**AMENDMENT No.2**

<b>Title-Sujet</b> Rocky Barachois Bridge Replacement – Gros Morne NP		
<b>Solicitation No. - No. de l'invitation</b> 5P201-18-0213/A		<b>Date:</b> January 29, 2019
<b>GETS Reference No. – No de reference de SEAG</b> PW-19-00859693		<b>Client Ref. No. – No. de réf du client.</b> 1845
<b>Solicitation Closes – L'invitation prend fin :</b>		
<b>at – à</b> 2:00 PM	<b>on – le</b> February 5, 2019	<b>Time Zone - Fuseau horaire</b> EST - HNE
<b>F.O.B. - F.A.B.</b>		
<b>Plant-Usine:</b> <input type="checkbox"/>	<b>Destination:</b> <input checked="" type="checkbox"/>	<b>Other-Autre:</b> <input type="checkbox"/>
<b>Address Inquiries to: - Adresser toute demande de renseignements à :</b>		
<b>Michel Marleau</b> michel.marleau@canada.ca		
<b>Telephone No. - No de téléphone</b> (613) 938-5822		<b>Fax No. – No de FAX:</b>
<b>Destination of Goods, Services, and Construction:</b> <b>Destinations des biens, services et construction:</b>

## **AMENDMENT No.2**

### **THE PURPOSE OF THIS AMENDMENT IS TO GIVE EFFECT TO THE FOLLOWING CHANGE;**

**GENERAL ARRANGEMENT SHEET 1 of 2**

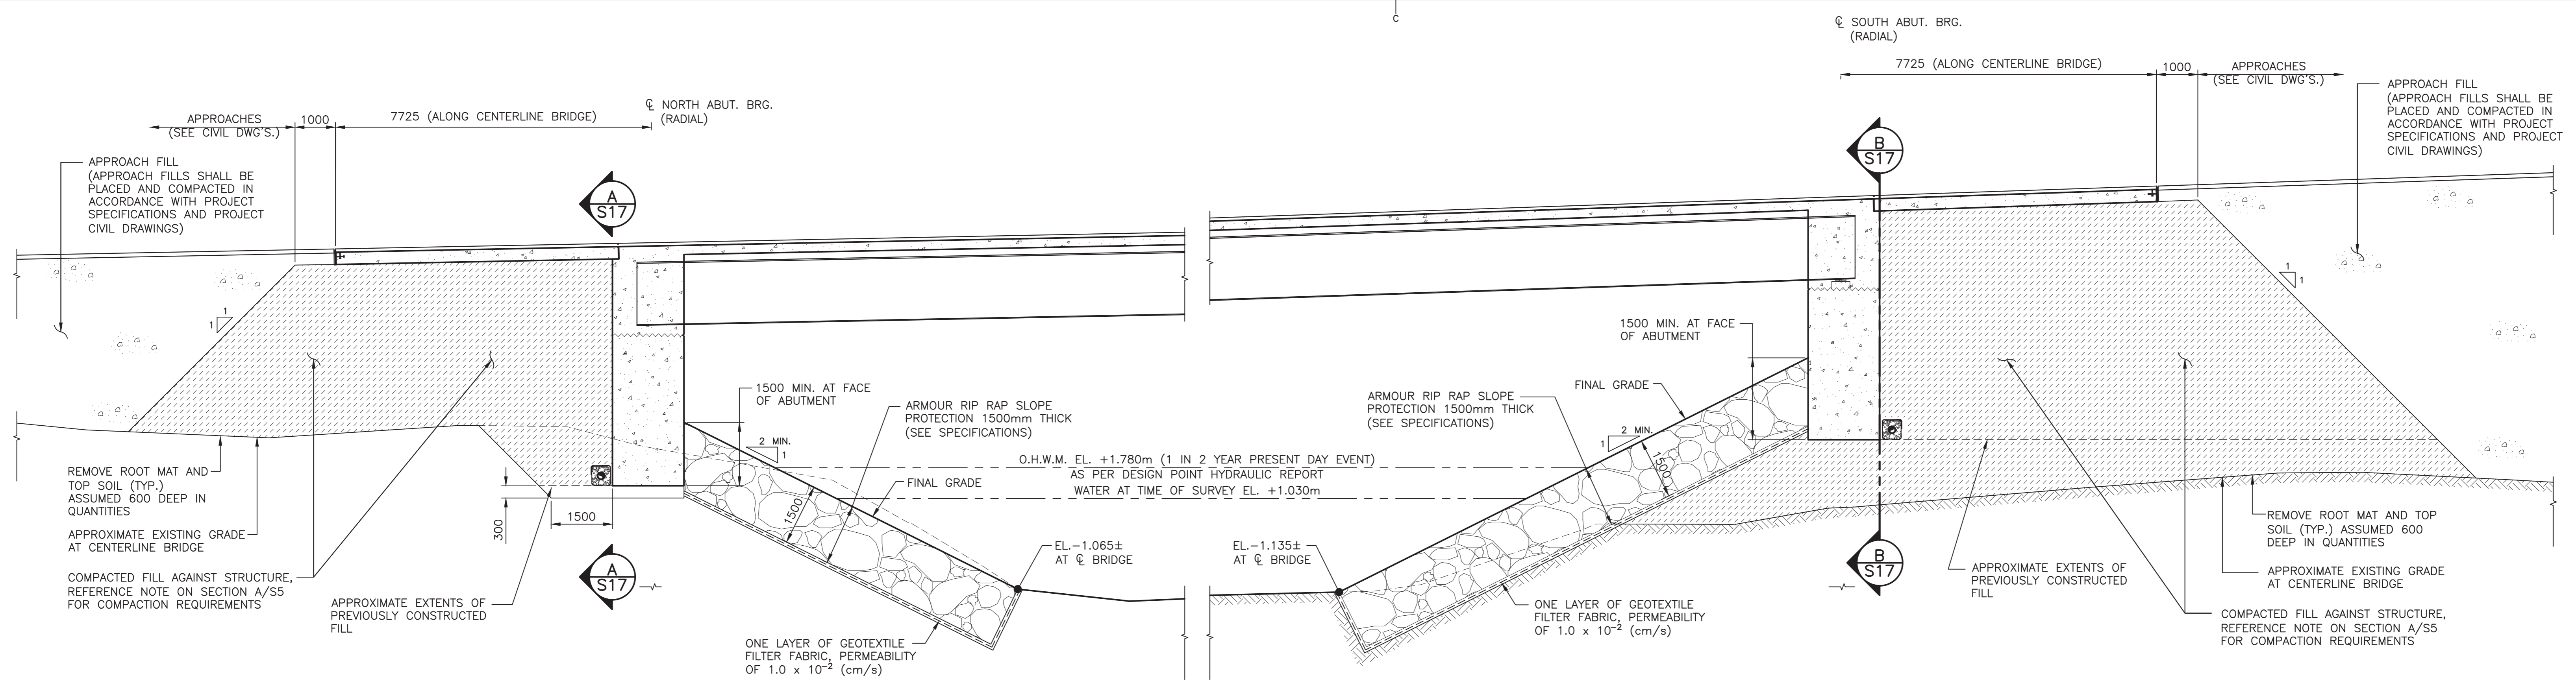
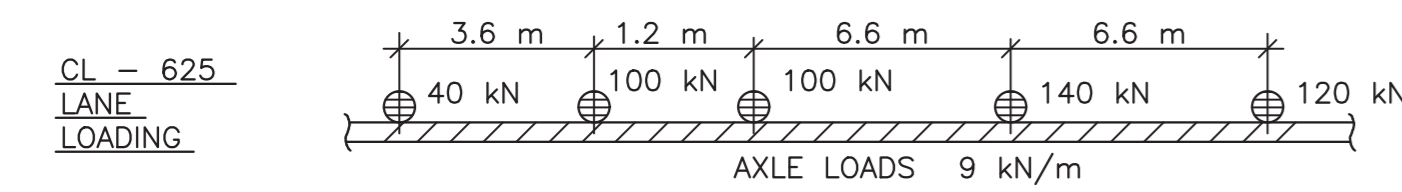
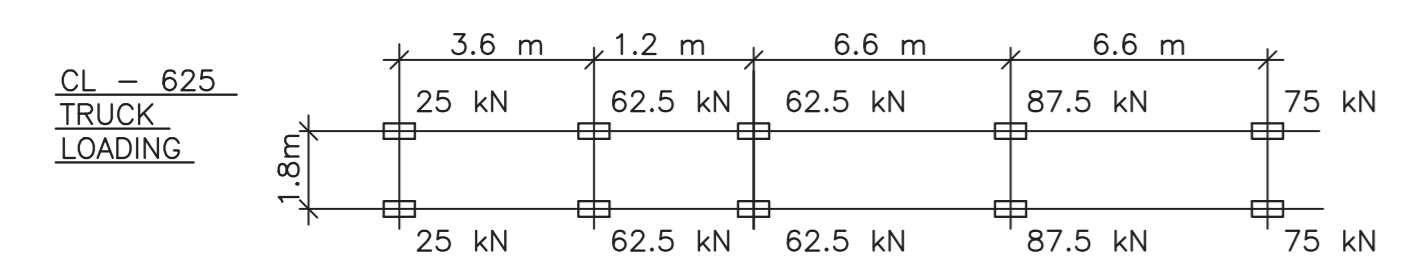
Drawing S1 - General Arrangement Sheet 1 of 2, Revision 1, Issued for Addendum, 01/24/2019.

drawing  
**BRIDGE EXCAVATION AND FILL QUANTITIES**  
design

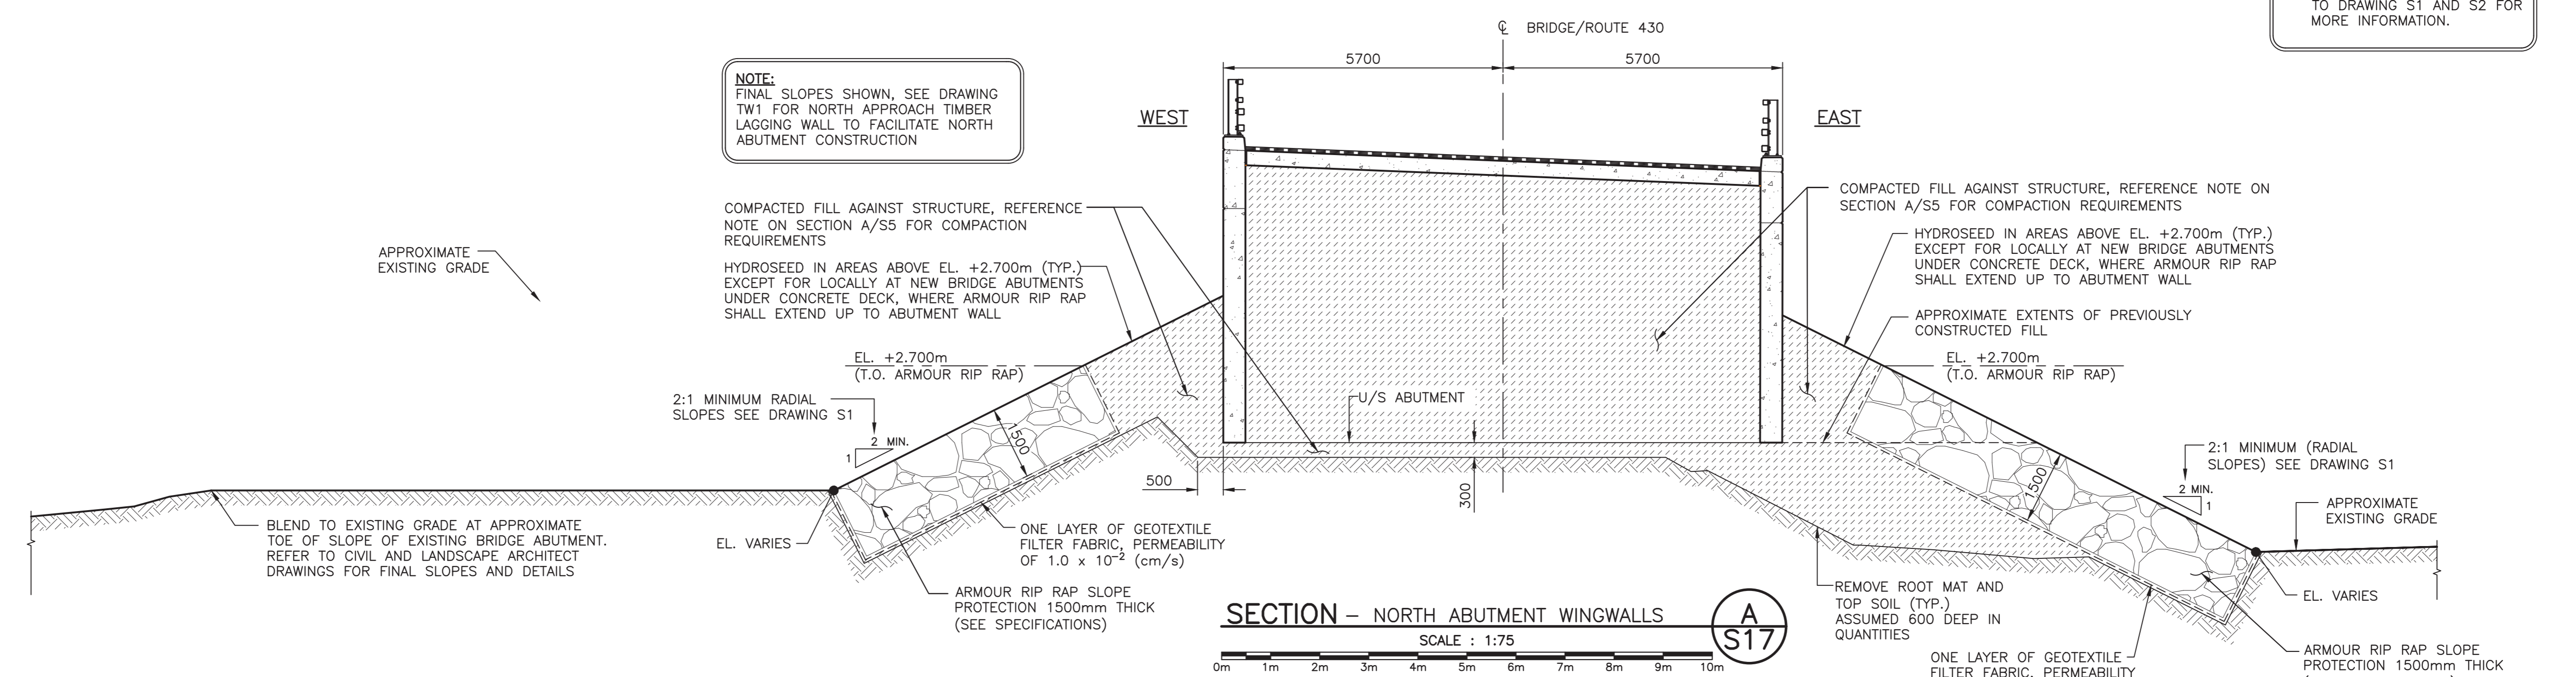
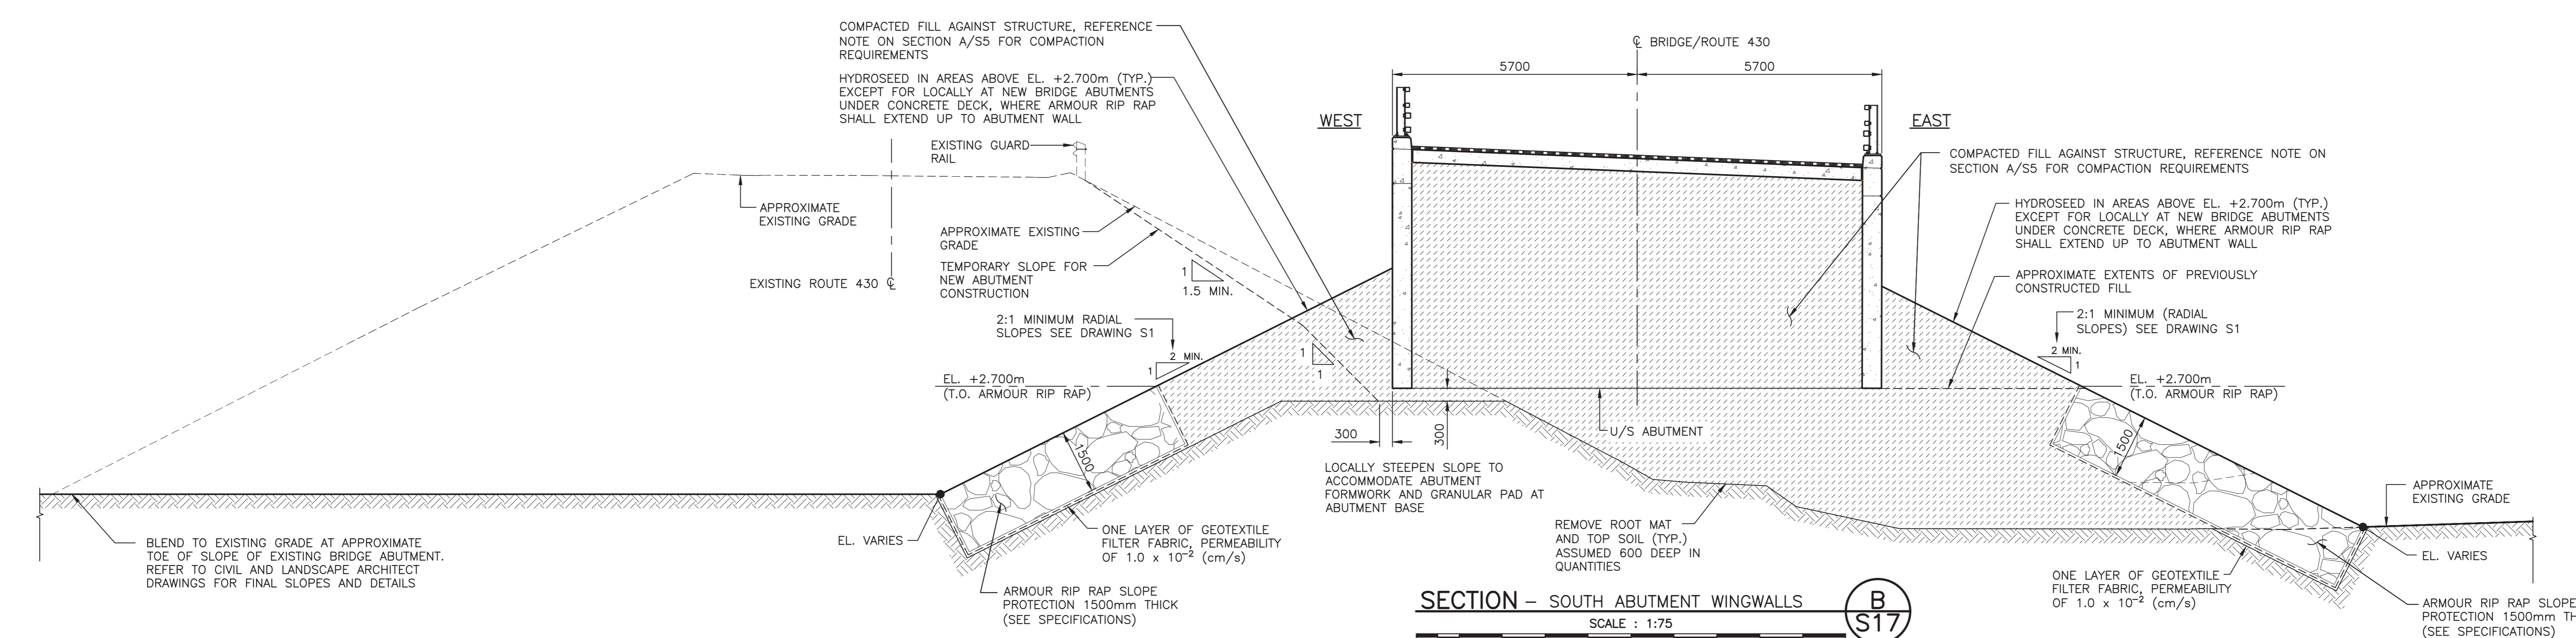
Drawing S17 - Bridge Excavation and Fill Quantities, Revision 1, Issued for Addendum, 01/24/2019.
